Addendum No. 1

Re: Laun Park – Splash Pad Improvements

Project #PR-079-22

Date: July 15, 2024

ELECTRICAL SCHEMATIC
 SCALE: N.T.S.

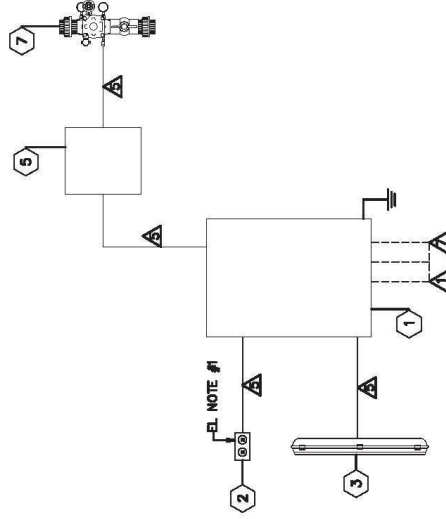
Item #1: Electrical Schedule and Schematics attached to this addendum.

Question: "Do you have any requirements on what size and voltage feed is required for the Splashpad controller?"

Answer: See schematic attached below for electrical demands provided by the equipment company. See Item #3, Clarifications, for on site meeting date and time. For additional information on meeting contact project manager Will Mastin. (will.mastin@cityofmobile.org) or by calling (251) 406-2678.
